Staff Report

Item: No Address along Stacy Allison Way “Allison Way Apartments” (DR 2019-05, EXCP 2020-05, PLA 2019-04, PP 2019-01, & VAR 2019-04)

Tax Lot(s): 052W14 02000, 02100, & 02300

Exhibit EX2b (This median example concept is not to scale.)

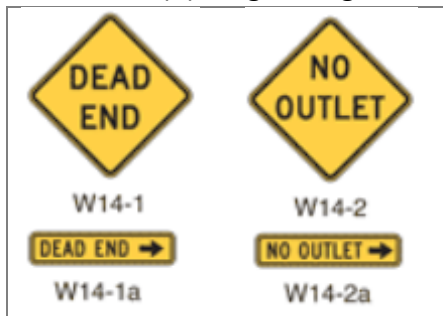
- (6) Median: Because along I-5 and between Hooper and driveway A2 no center turn lane is needed, a median planter shall taper open as turning areas taper closed – a length of approximately 800 ft. The median shall be defined through either of the following two options:

- (i) Turnaround: Include roughly in the middle of the long axis of the median an emergency turnaround with civil engineering details as the City Engineer directs. To draft an initial design to which the City can respond during the permit stage, assume curb radii for design vehicle type P (passenger car) and along east/SE and west/NW curves mountable curb for AASHTO design vehicle type WB-67 (tractor trailer truck). Propose either an obvious or subtle concept, obvious meaning noticeable and usable by the general public in passenger cars and emergency trucks (e.g. U-turn asphalt flowing between the travel lanes), and subtle meaning visible and usable only by emergency trucks (e.g. mountable curb, curb reflectors, and with passage at a higher elevation than that of the travel lanes and paved with either generic “grasscrete” or concrete stamped or otherwise treated to have a pattern, something no passenger car drivers would perceive as for them). For the obvious, assume asphalt minimum width eighteen (18) ft width at narrowest point; for the subtle, assume concrete minimum width eleven (11) ft wide or grasscrete minimum width twenty (20) ft wide.

- (ii) Root barriers: Install to protect both travel lanes.

Exhibit T-BP10A. Location and Conceptual Alignment

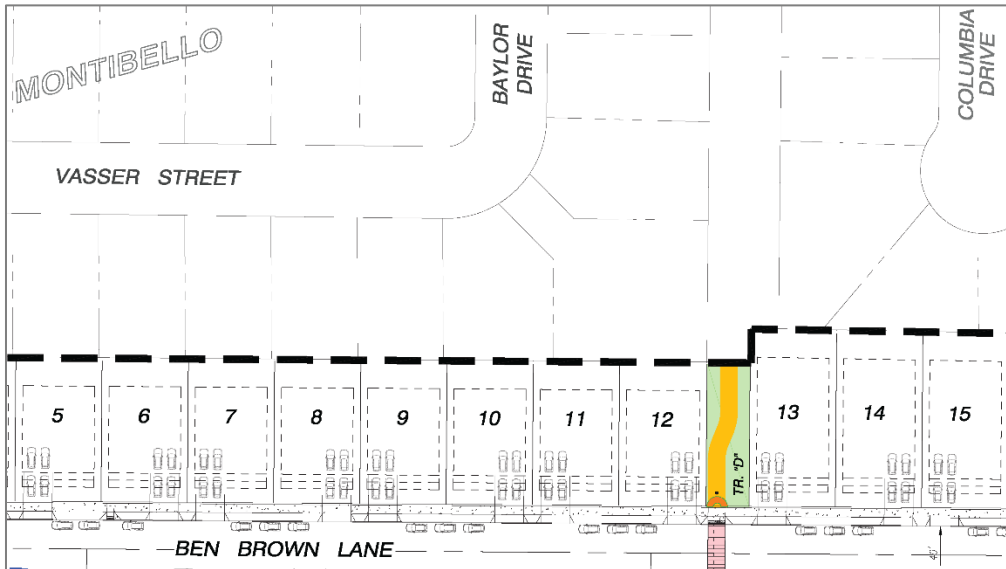
T-BP10. BP fee in-lieu option: In order for the City to construct any of the bicycle/pedestrian improvements that Condition T-A1b (Evergreen sidewalk west) and the T-BP conditions above describe, a developer may pay a fee in-lieu as follows:

Figure 3.05C - Parking Space Striping

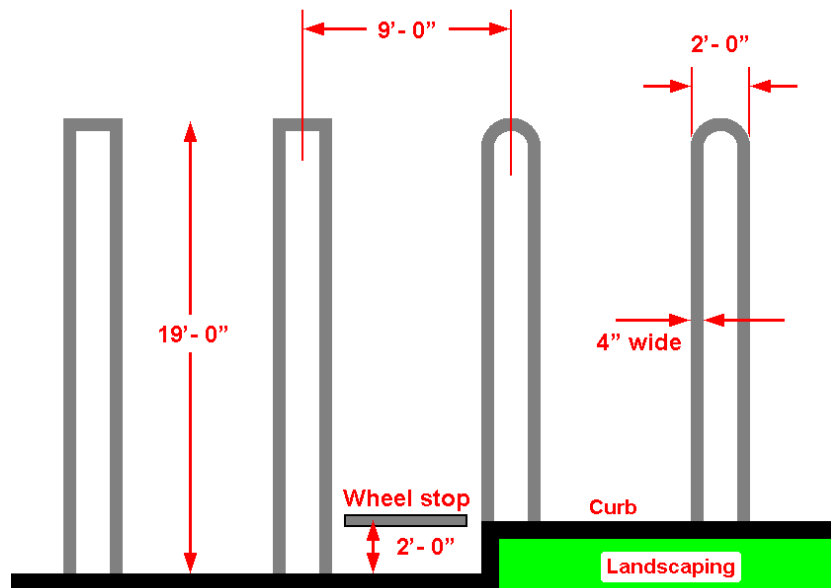
The applicant proposes all stalls, which are all at 90°, to the drive aisle with dimensions, double-striping, and curbing that meet or exceed the minimum standards – except as regards the variance request for drive aisle width minimum.

Exhibit EX2b (This median example concept is not to scale.)

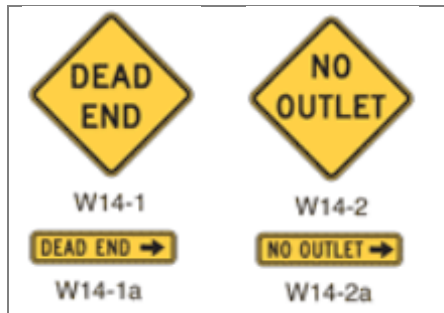
- (7) Turn areas: At the north, the median shall taper to accommodate a turning radius as directed by the City Engineer for vehicles heading westbound on Hooper to Allison southbound. At the south, the median shall taper to accommodate the center left turn lane for vehicles eastbound into both driveways A2 & A3. The turn lane shall continue with the travel lanes to the dead-end of ROW. The taper shall be such that the turn lane is at minimum width for a length north from driveway A2 to accommodate at the same time the queuing of both an AASHTO design vehicle type WB-67 (tractor trailer truck) and design vehicle type P (passenger car) with distance between the two. As a clear and objective standard, the developer may default to a hundred (100) ft. This means the median may taper open with curb beginning at the above minimum length from A2.

Exhibit T-BP South: This exhibit illustrates locations and represents improvements related to Conditions T-BP6 through 8. Sidewalk is in blue dashes and ADA ramps are in yellow trapezoids.

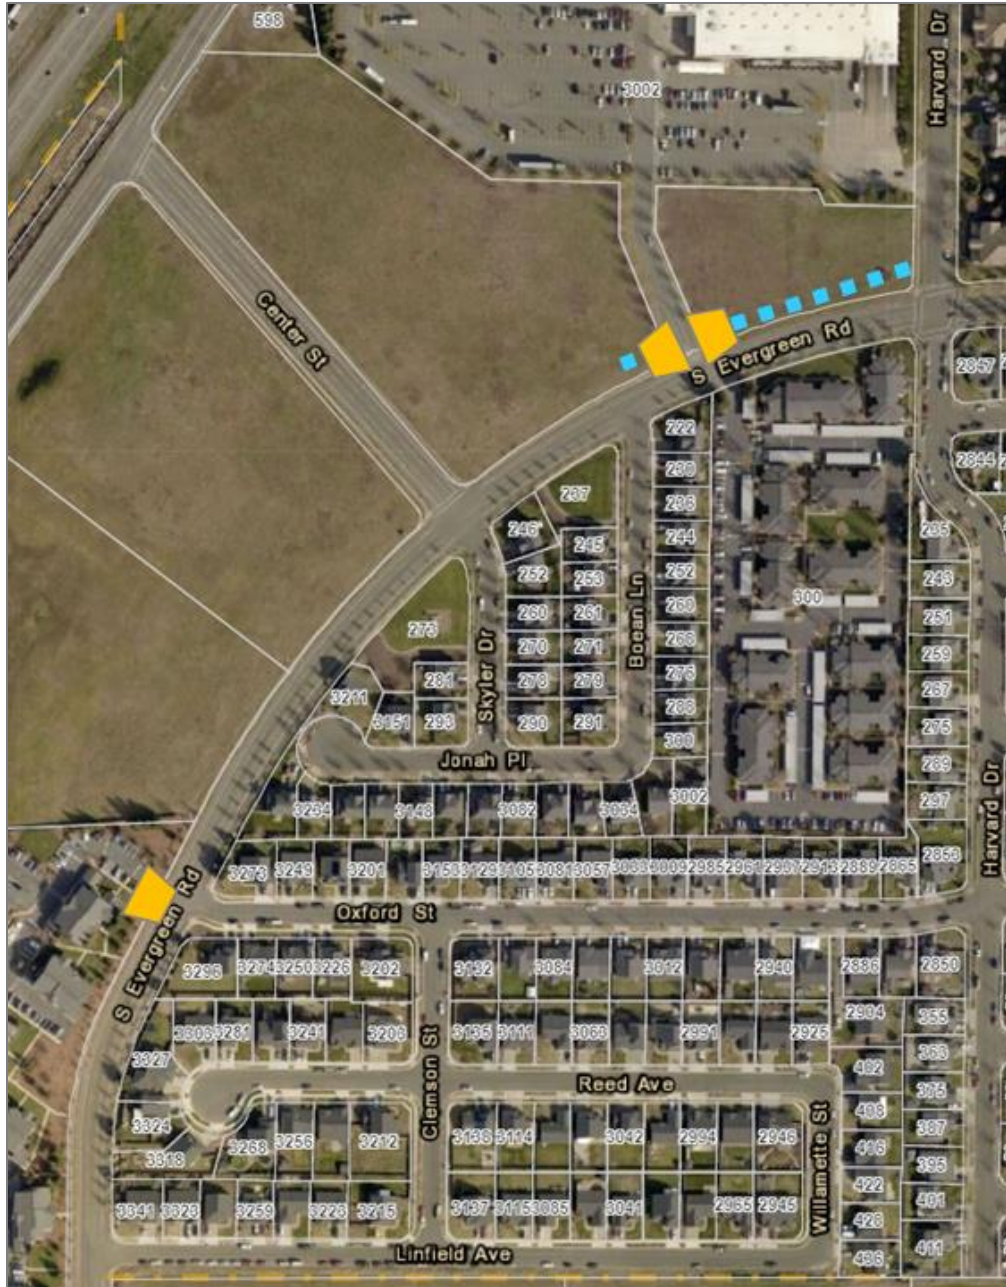
T-BP6. Evergreen sidewalk south: The developer shall fill in the sidewalk gap along the Evergreen frontage of Tax Lot 052W12C 02400 (0 Evergreen Road NE). The minimum width and placement shall conform to WDO Figure 3.01C, and within the planter strip the applicant shall plant at least two (2) street trees with root barriers, one each near Harvard and the driveway and to allow future adjacent site development to add trees to conform fully with the quantity required by WDO 3.06.03A (1 per 50 ft typical). This is due by Phase 2, building permit issuance.

T-BP8. Evergreen curb ramp(s): At the T-intersection with Oxford, the developer shall install at least one ADA-compliant curb ramp at the west end of either the north or south leg crosswalk, pave new sidewalk minimum six (6) ft wide that connects to existing sidewalk, and stripe the crosswalk. The applicant shall to the extent feasible save existing street trees, including by using returned curbs instead of flares along ramps. This is due by Phase 1, building permit issuance.

T-BP9. Evergreen Path: The developer shall pave an ADA-compliant bicycle/pedestrian path minimum twelve (12) ft wide:

Exhibit T-BP10A. Location and Conceptual Alignment

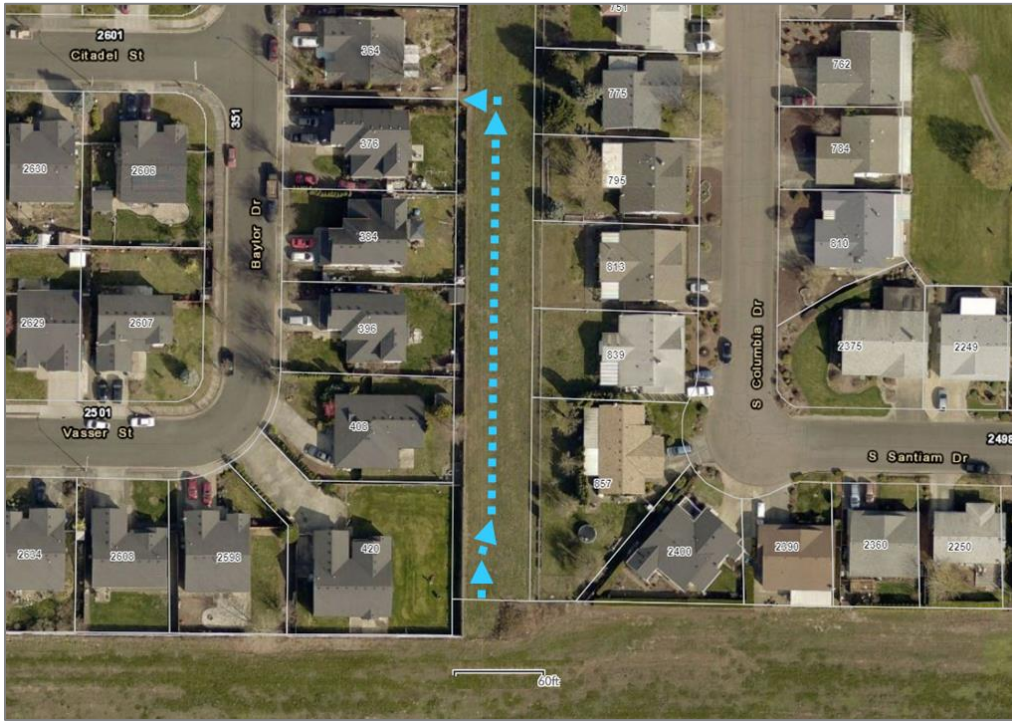
This is due by Phase 1, building permit issuance. [P49]

T-BP10. BP fee in-lieu option: In order for the City to construct any of the bicycle/pedestrian improvements that Condition T-A1b (Evergreen sidewalk west) and the T-BP conditions above describe, a developer may pay a fee in-lieu as follows:
